ARCHITECTURAL ADVISORY COMMITTEE MEMORANDUM

SUBJECT: REQUEST BY RYAN ALVAREZ, ON BEHALF OF WAL-MART STORES LLC., FOR A MAJOR ARCHITECTURAL APPLICATION FOR THE DEVELOPMENT OF A FUEL STATION AND CONVENIENCE KIOSK LOCATED AT 5601 EAST RAMON ROAD, ZONE M-1 (CASE 3.4210 MAJ).

FROM: Development Services Department

SERVICE BUILDING ELEVATIONS

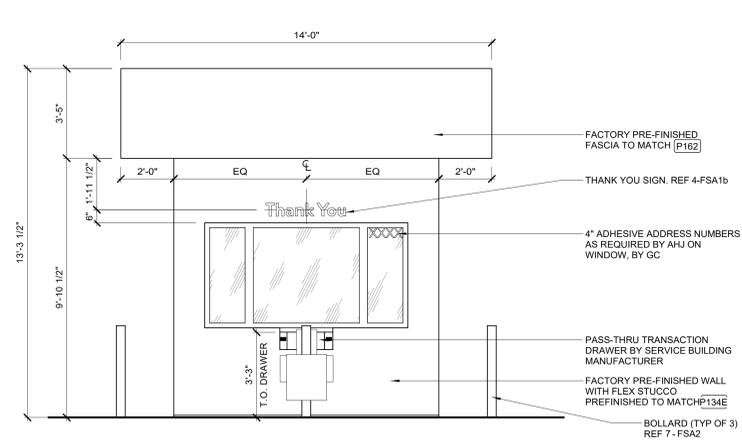
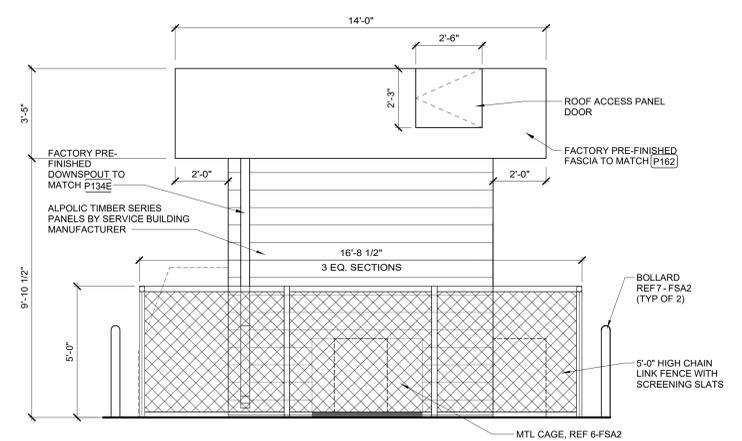
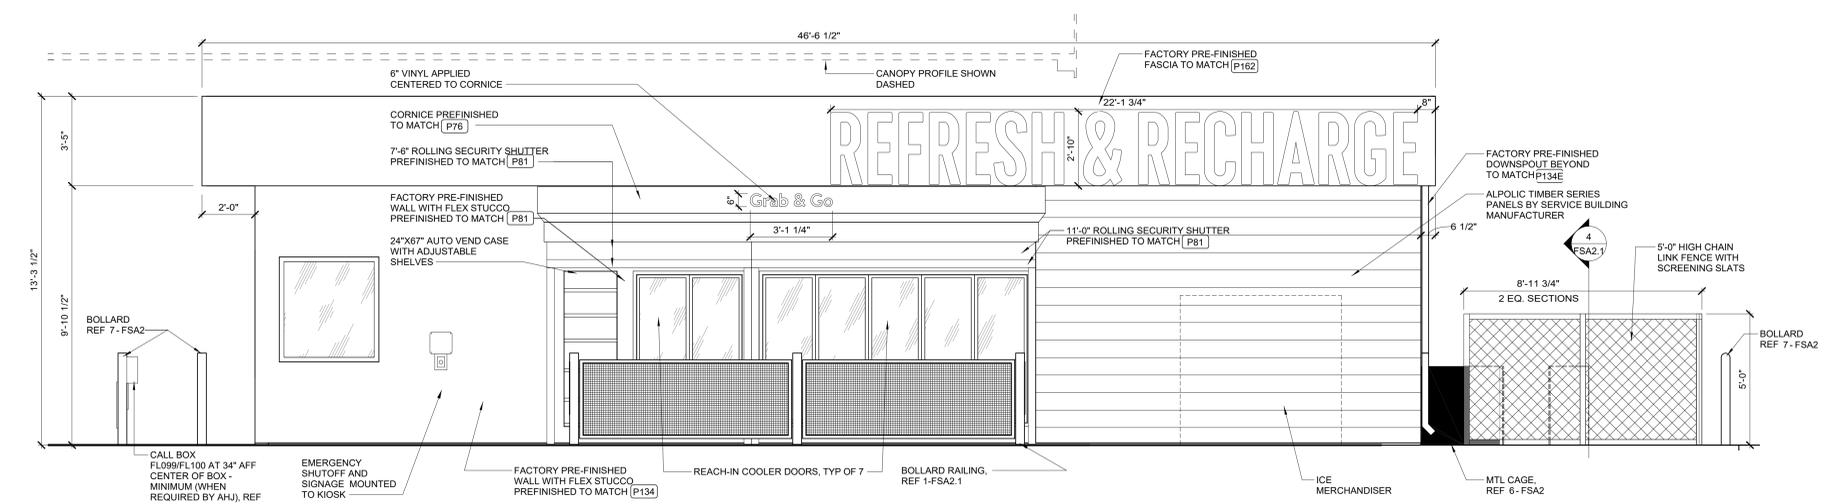
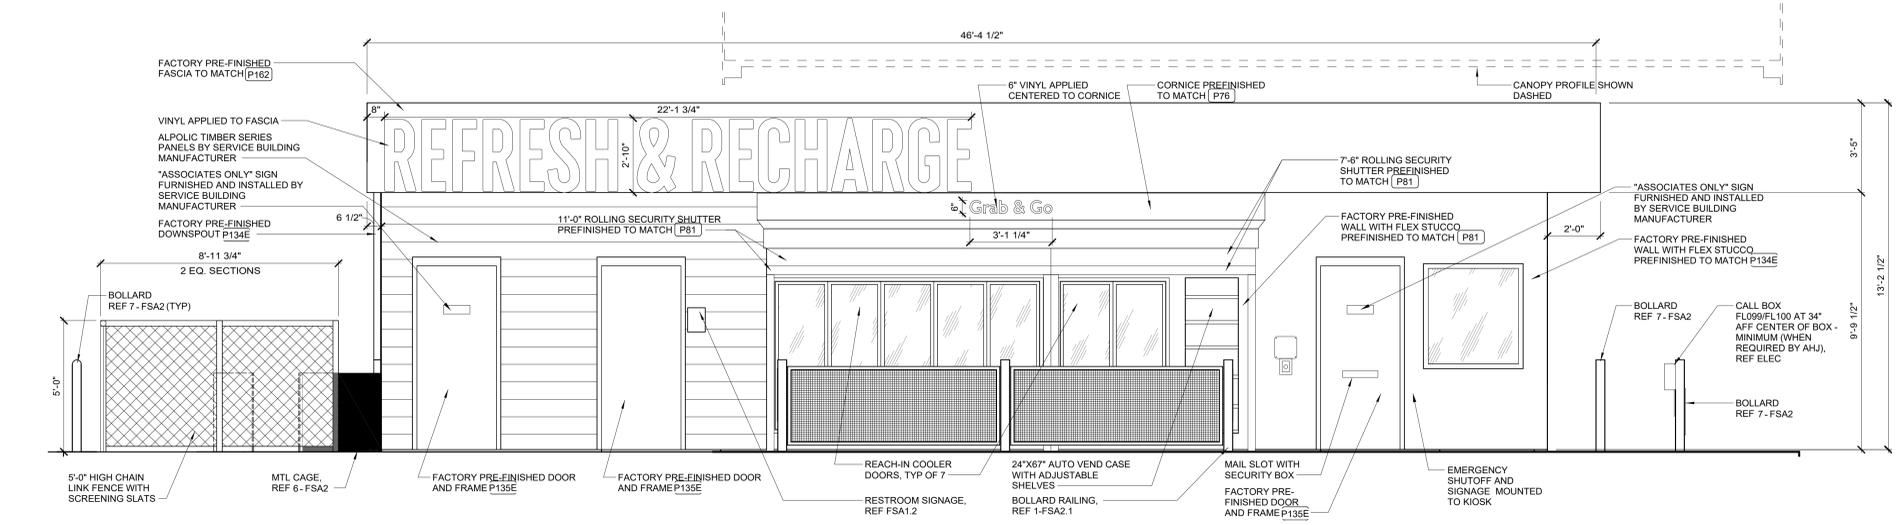
2.	<p><i>Harmonious relationship with existing and proposed adjoining developments and in the context of the immediate neighborhood/community, avoiding both excessive variety and monotonous repetition, but allowing similarity of style, if warranted;</i></p> <p>The proposed kiosk is a programmatic prototypical pre-manufactured building that is the standard copy-righted design of Walmart. With its contemporary design, the commercial building will enhance the undeveloped property; however, it is not harmonious to the surrounding area, as it provides vending doors on the exterior elevations.</p>	N

A PHOTOMETRIC SITE PLAN
1' = 20'

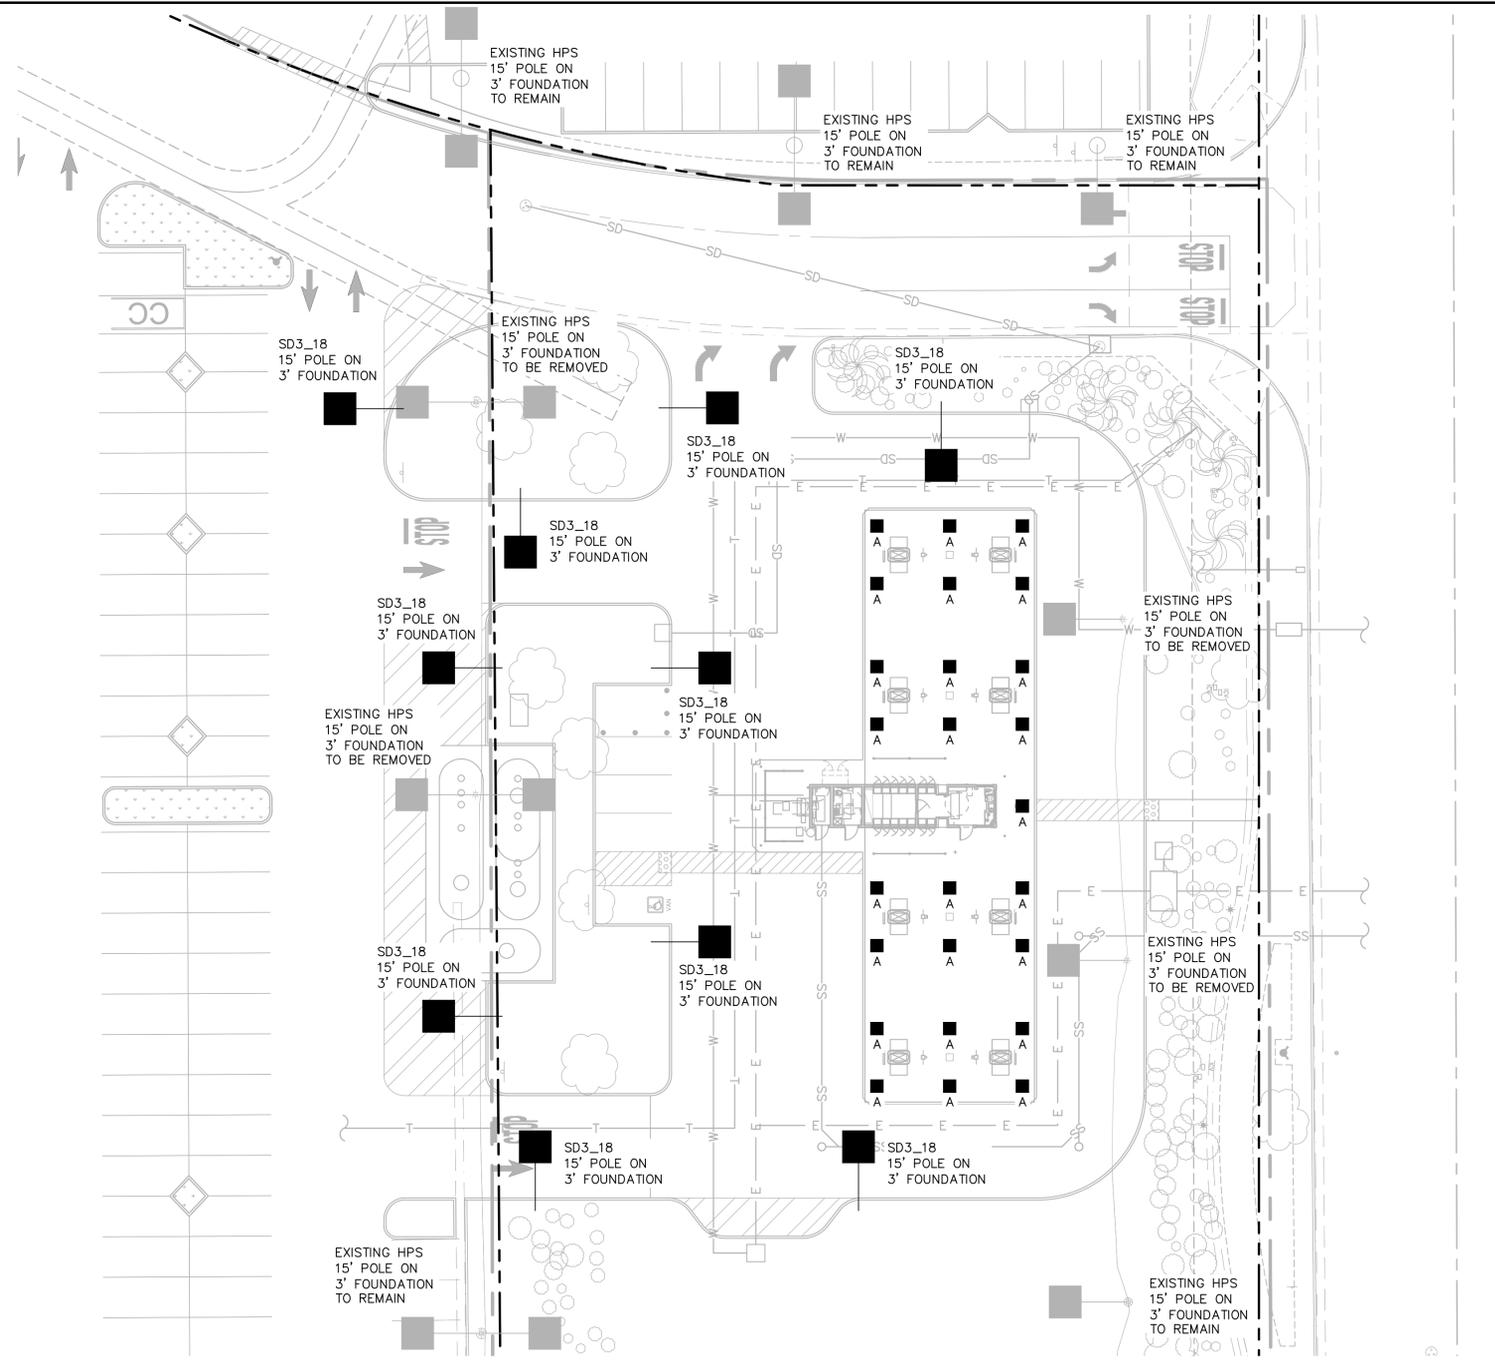
- There are no proposed lights within the landscaped areas.
- The size of the kiosk does not meet the minimum size requirement for automotive service stations.
- The southern portion of the parcel will remain undeveloped.
- Vending doors are proposed on the exterior elevations.

- Add lighting within the landscaped areas.
- Increase the building square footage to a minimum 750-square feet and orient all retail indoors, per Section 93.23.01 of the Zoning Code.
- Submit a Sign Program Amendment application for Walmart.
